LOCAL PLANNING PANEL – THE HILLS SHIRE COUNCIL

DETERMINATION OF THE HILLS LOCAL PLANNING PANEL ON 17 APRIL 2024

**ITEM 1: LOCAL PLANNING PANEL – PLANNING PROPOSAL – NORWEST
MARKETOWN – 4-6 CENTURY CIRCUIT, NORWEST (4/2024/PLP)**

Figure 12
Building separation for residential towers (highlighted red)

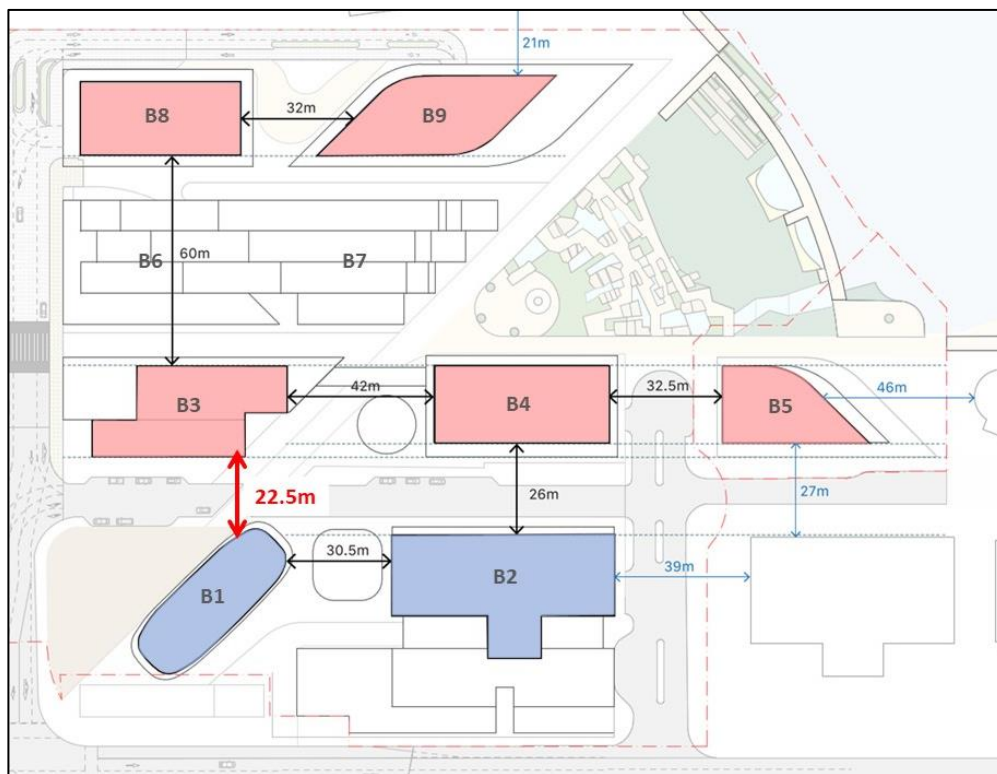
The building separation for residential developments appears to comply with the ADG requirements with the exception of separation between the residential building B3 and commercial tower B1 which is a minimum ranging from 20m - 22.5m.

Should the planning proposal proceed to Gateway Determination the development concept should be amended to demonstrate the ability to achieve the minimum residential building separation of 24m for 9 storeys and above.

Overshadowing impact of proposed development between 9am and 3pm on June 21
(Station site highlighted in red)

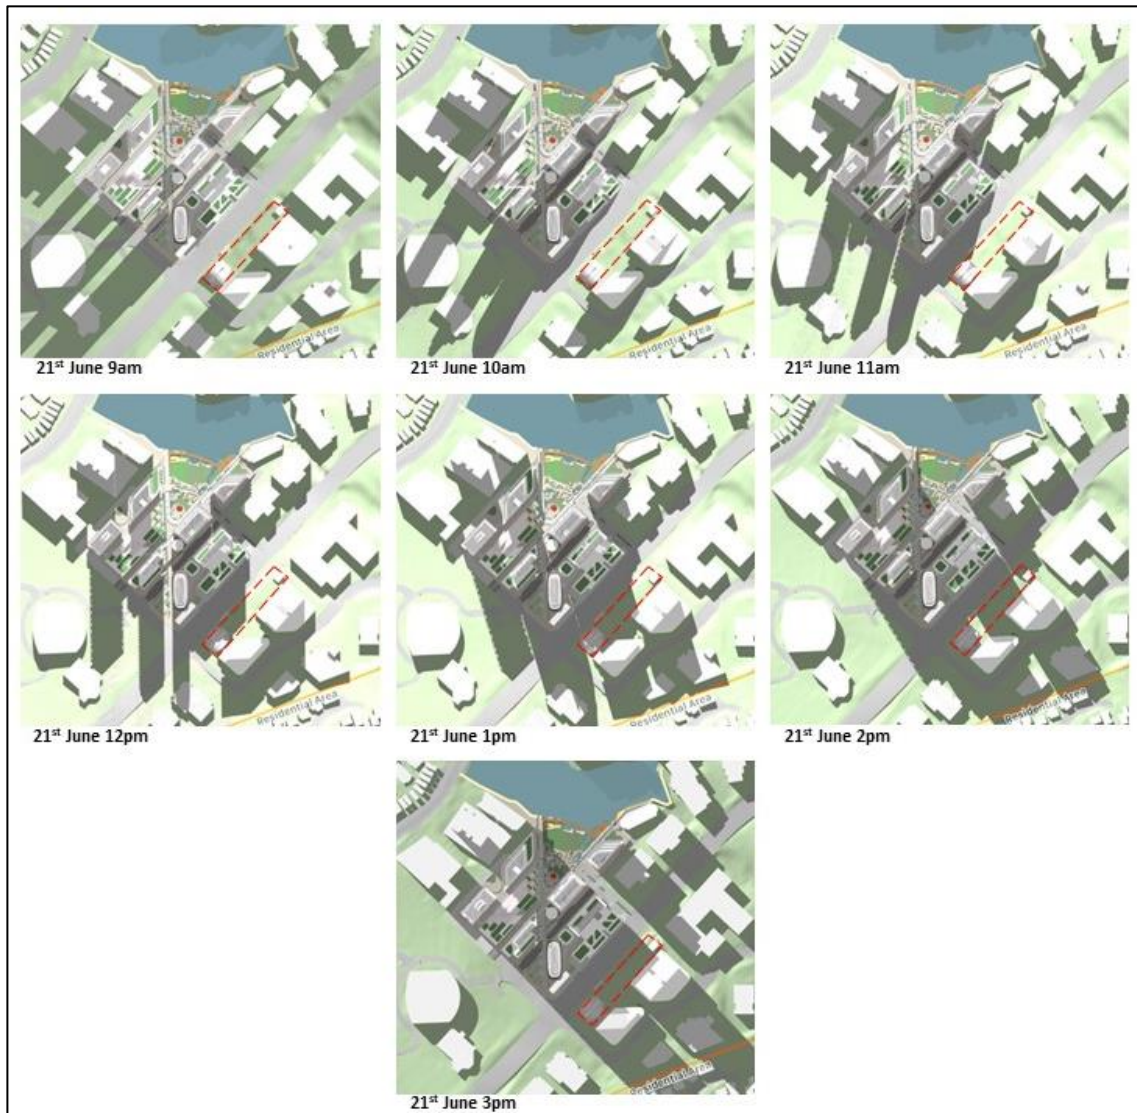
The concept plans indicate that the Station Site is likely to experience significant overshadowing. Considering the other surrounding sites are also likely to redevelop, the proposed building heights and orientations may require modification to improve solar access to the Norwest Station Site and it is recommended that additional controls are included in the site specific DCP to ensure appropriate solar access to the Station Site is retained.

Figure 14
Solar access to Lakeshore Park and Public Space (viewed from Norwest Lake)

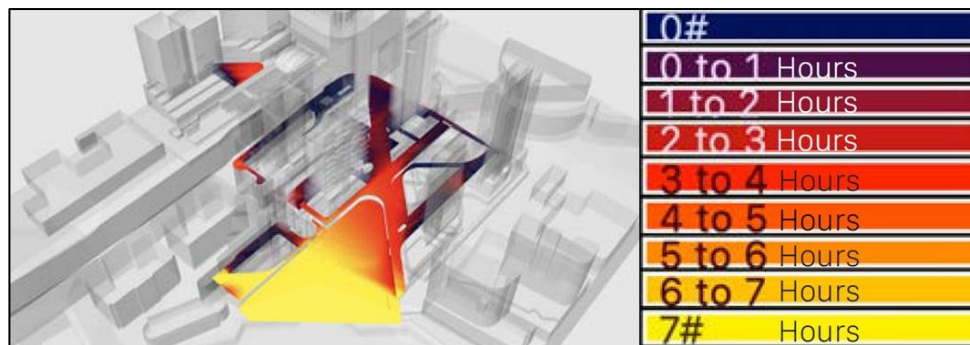
Whilst the Lakeshore Park receives sufficient solar access the remainder of the ground floor public domain appears to receive significant overshadowing. Lack of adequate solar access to the ground plane will impact the proposed landscaping and amenity of the outdoor areas. The proposed building heights and orientations may require modification to allow for increased solar access to the ground plane.

View from Bella Vista Farm towards proposed development (north-east)

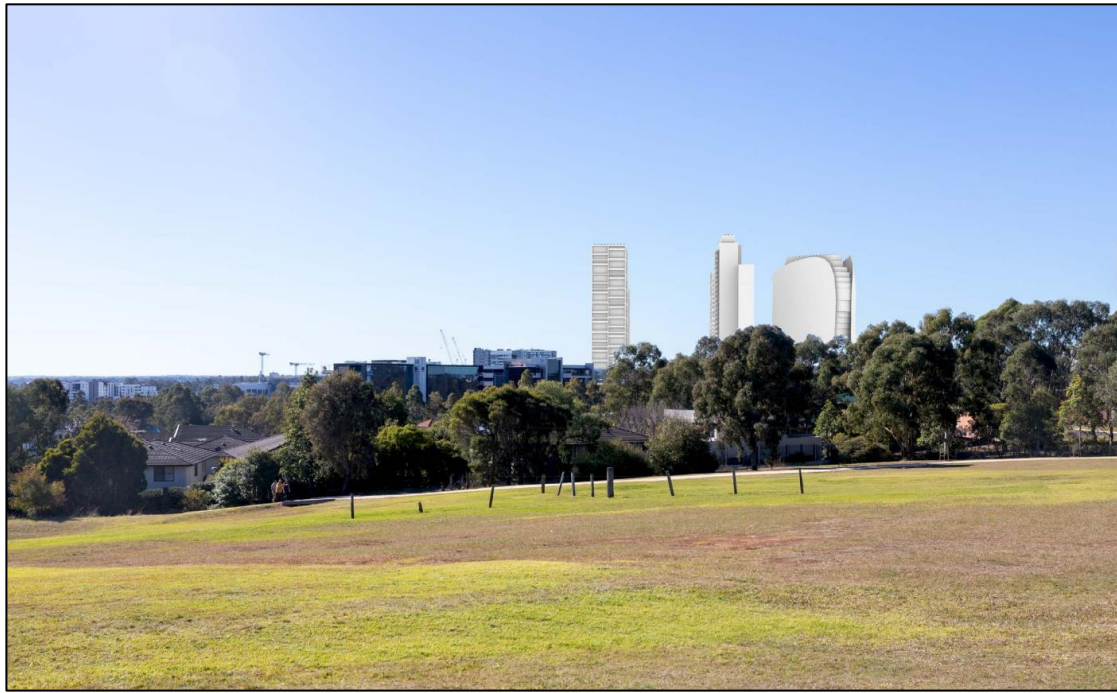
The subject site is located approximately 1km from Bella Vista Farm. The distance from the heritage item as well as the slender built forms depicted in the development concept would reduce the potential impact of the planning proposal on view corridors from Bella Vista Farm. Furthermore, as Norwest has been identified as a key strategic centre, the Norwest skyline and future views from Bella Vista Farm towards Norwest Station are likely to undergo significant transformation as a result of the role, function and growth targets and projections for this area under Government planning policies. Should the planning proposal proceed to Gateway Determination, further consultation would be undertaken with Heritage NSW.
